AEP:NRC:3054-06  
10 CFR 2.202

Donald C. Cook Nuclear Plant Unit 1 and Unit 2  
RESPONSE TO REQUEST FOR ADDITIONAL INFORMATION  
REGARDING RELAXATION OF REACTOR PRESSURE VESSEL HEAD  
PENETRATION INSPECTION REQUIREMENTS IN NUCLEAR  
REGULATORY COMMISSION ORDER

## ATTACHMENT 1 TO AEP:NRC:3054-06

### RESPONSE TO REQUEST FOR ADDITIONAL INFORMATION

Sketch of D.C. Cook Unit 1 and Unit 2 Reactor Vessel Head Penetration  
(Not to Scale)

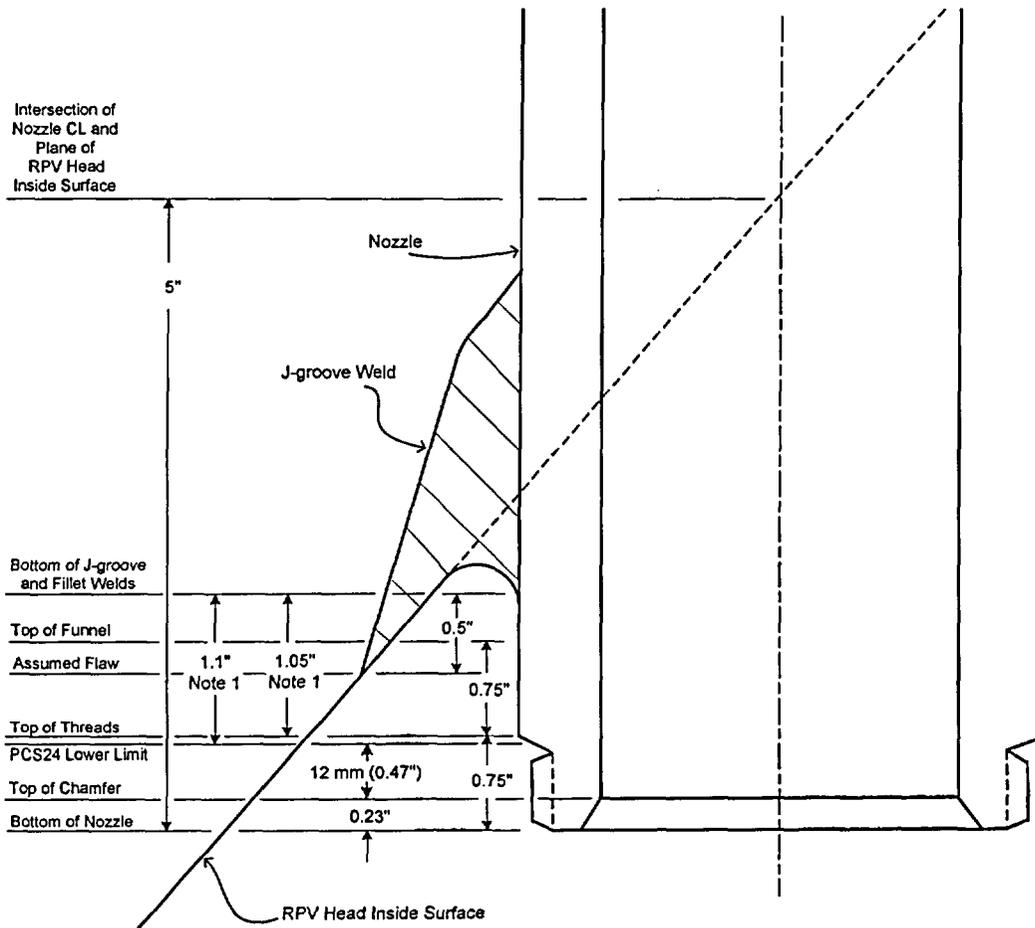
The licensee stated that a small portion of base material will not be scanned on the bottom of the nozzle because the lower transducer and the upper transducer of the probe need to be in contact with the nozzle material. The distance from the bottom of the nozzle upward that cannot be scanned is 12 mm. Please identify the minimum distance from the J-groove weld to the location on the nozzle that cannot be scanned.

The licensee is requested to provide a sketch of the nozzle with the necessary dimensioning to clarify the areas covered by the request.

Provide the distance from the bottom of the weld to the point where ET/PT cannot be performed.

As shown in the sketch provided at the end of this attachment, the distance from the bottom of the nozzle upward that cannot be scanned due to the PCS24 probe transducer arrangement has been calculated to be 12 millimeters (0.47 inches) plus the height of the chamfer (0.23 inches). The minimum distance downward from the J-groove weld to the location on the nozzle that cannot be ultrasonically scanned due to the PCS24 probe transducer arrangement has been calculated to be 1.1 inches. Due to the curvature of the RPV head, this minimum distance only occurs at one point on the downhill side of the outermost penetrations (six penetrations on Unit 1 and five penetrations on Unit 2).

A sketch has been provided at the end of this attachment.

The nozzles that have guide funnels installed are the outermost nozzles. As shown in the sketch provided with this attachment, the guide funnels extend approximately 0.75 inches above the threads. Consequently, the minimum distance from the J-groove weld to the location on the nozzle that cannot be examined by eddy current testing or dye penetrant testing on nozzles that have funnels installed is less than the distance assumed in the crack growth calculation described

GRAPHS OF STRESS VERSUS DISTANCE BELOW J-GROOVE WELD

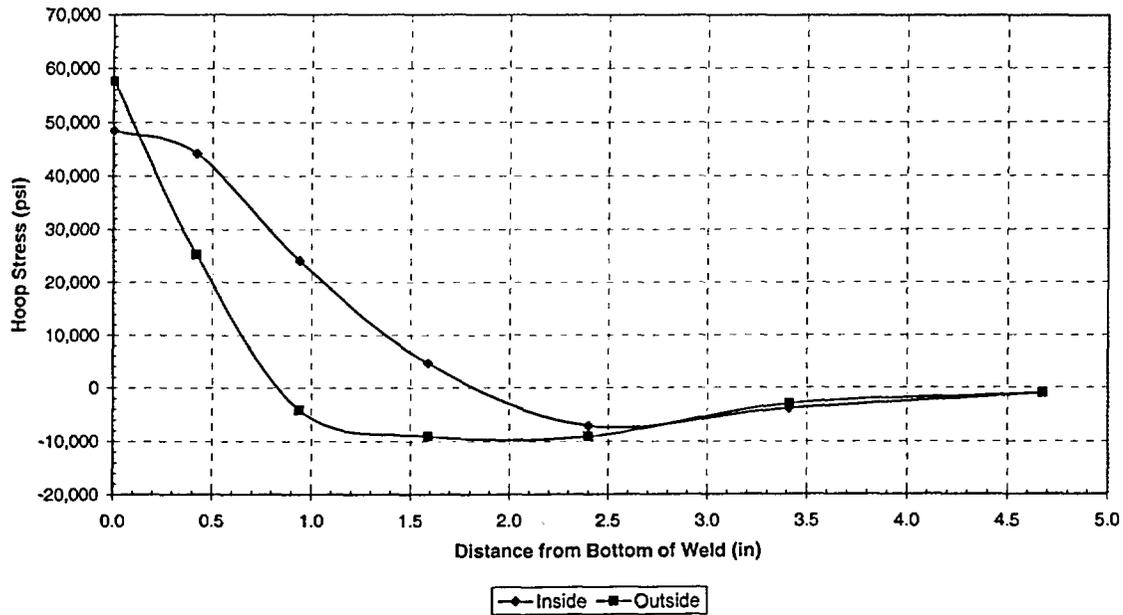
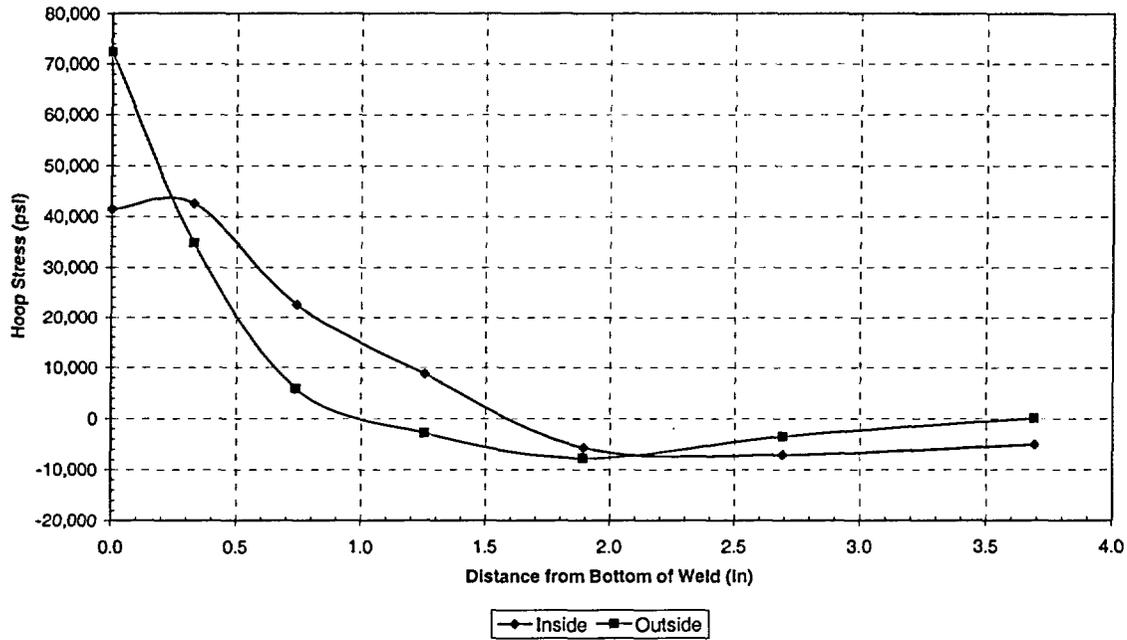
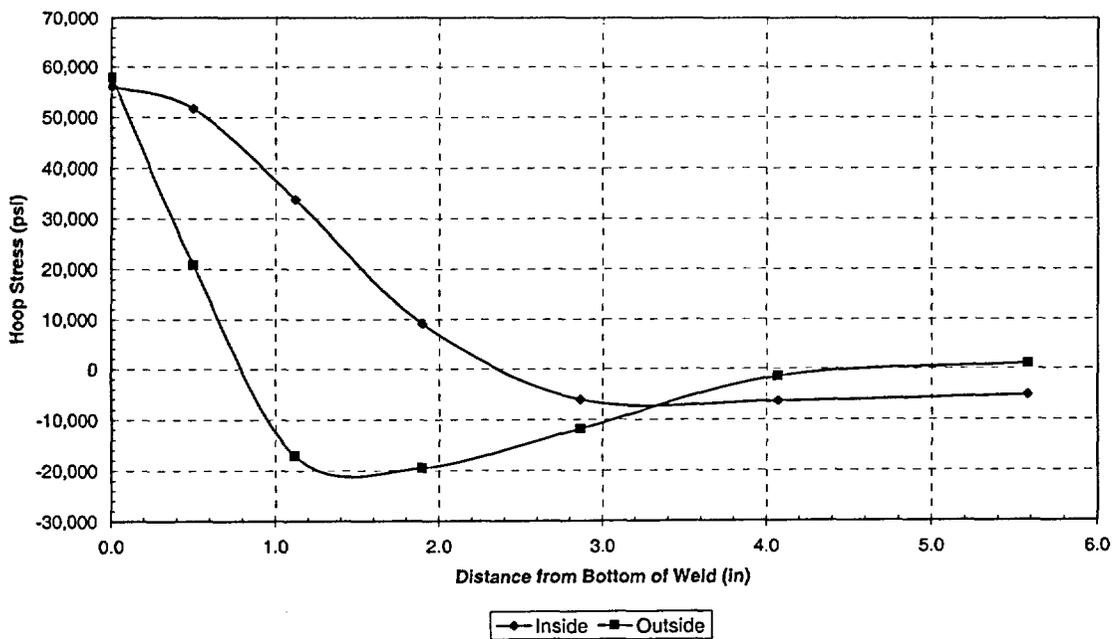
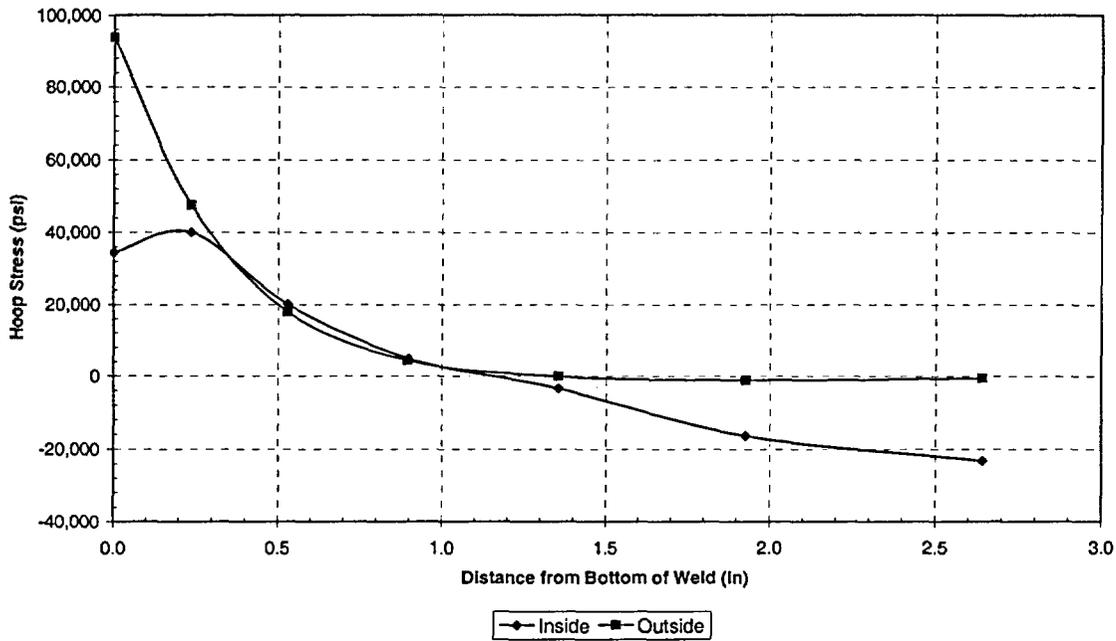
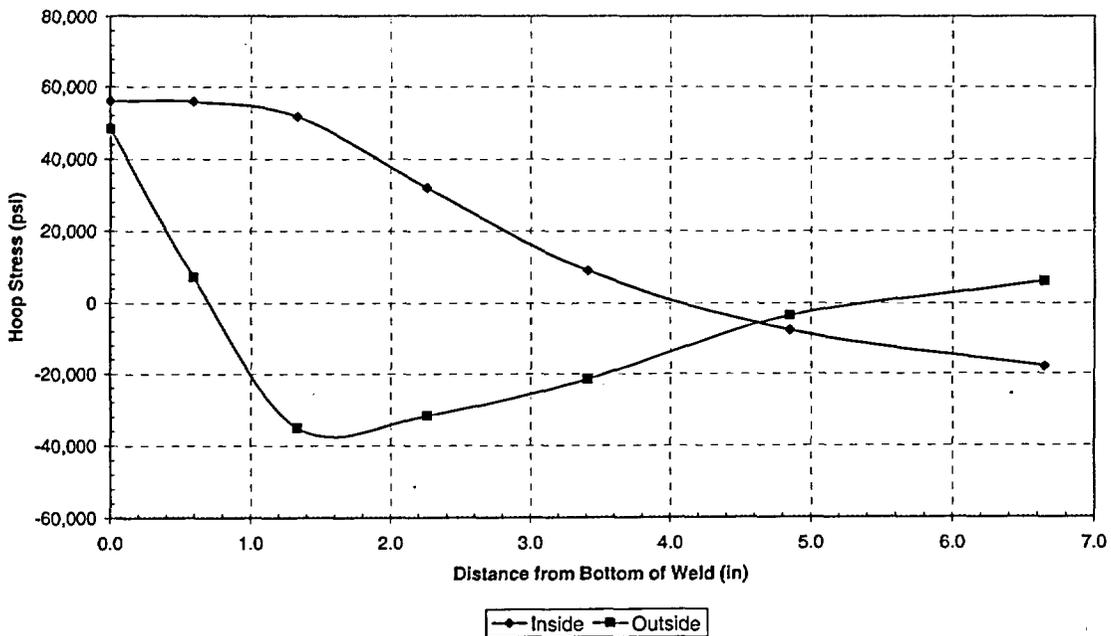
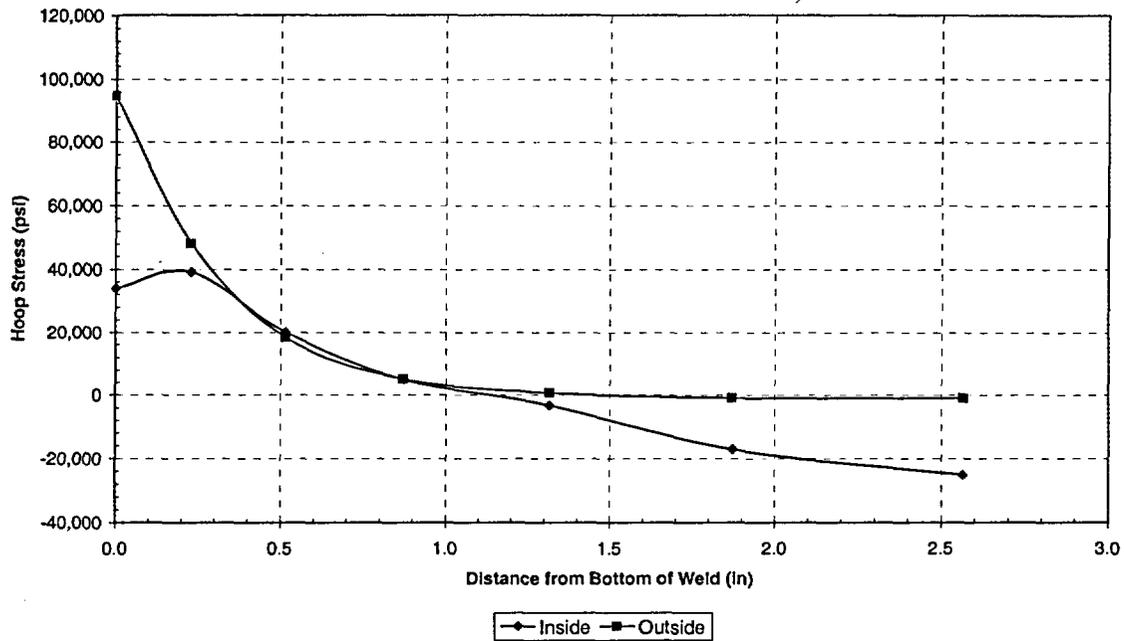
Provide additional technical justification (i.e., operating stress levels, crack growth analysis, etc.) that supports the licensee's statement that the small area that cannot be scanned is insignificant to the phenomena of concern.

The operating stresses in that area are shown in Attachment 2 to this letter, which provides graphs of hoop stress versus distance below the J-groove weld for various nozzles from the center of the Unit 2 RPV head to the outermost row. As shown in these graphs, the stresses in the area of the nozzle that would not be inspected are low relative to the yield stress of the nozzle material (41,000 to 63,000 pounds per square inch).

**Hoop Stress Distribution Below the Weld Downhill Side  
(50.5° CRDM Penetration Nozzle)**

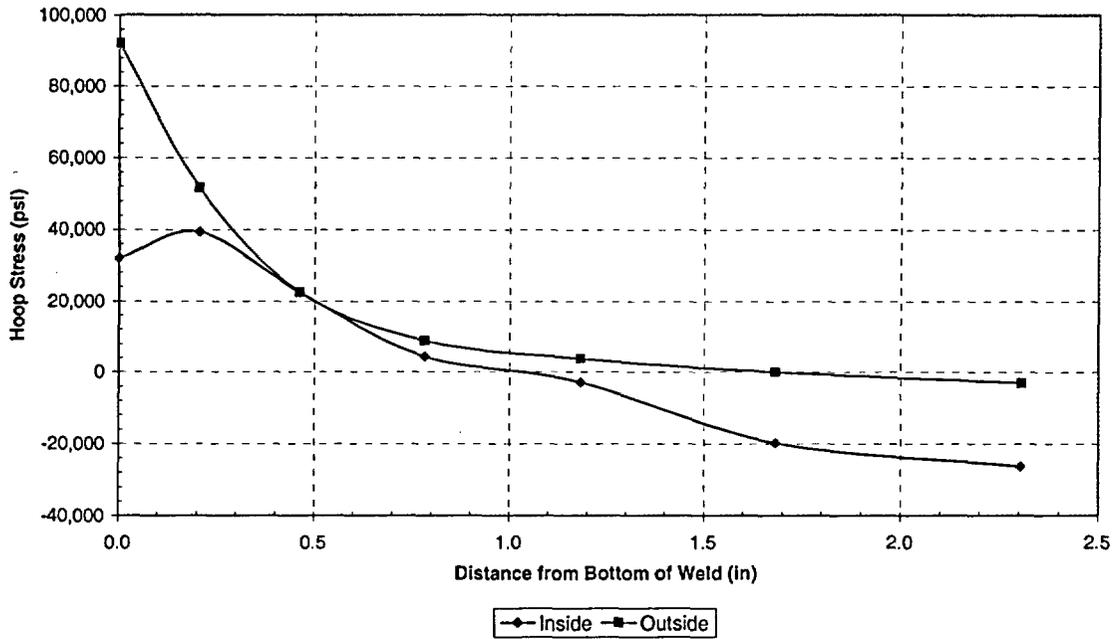
The licensee stated that at least five nozzles are threaded approximately 0.75 inches at the bottom of the nozzle. Provide the distance from the bottom of the weld to the threaded area that cannot be examined by UT. Additionally, please provide a more exact count of the nozzles that would be affected.

The minimum distance from the J-groove weld to the threaded area has been calculated to be 1.05 inches. Due to the curvature of the RPV head, this minimum distance only occurs at one point on the downhill side of the outermost penetrations (labeled 50.5° in Attachment 2, six penetrations on Unit 1, five penetrations on Unit 2). The minimum distance from the J-groove weld to the threaded area for all other points on these penetrations, and for all points on the other 73 penetrations, exceeds this value. As indicated in the response to NRC Question 1 above, the minimum distance from the J-groove weld to the location on the nozzle that cannot be ultrasonically scanned due to the PCS24 probe transducer arrangement has been calculated to be 1.1 inches. Since this value is approximately equal to the 1.05 inch minimum distance to the threaded area, the minimum distance from the J-groove weld to the location on the nozzle that cannot be ultrasonically inspected due to both causes will be considered to be approximately 1 inch.
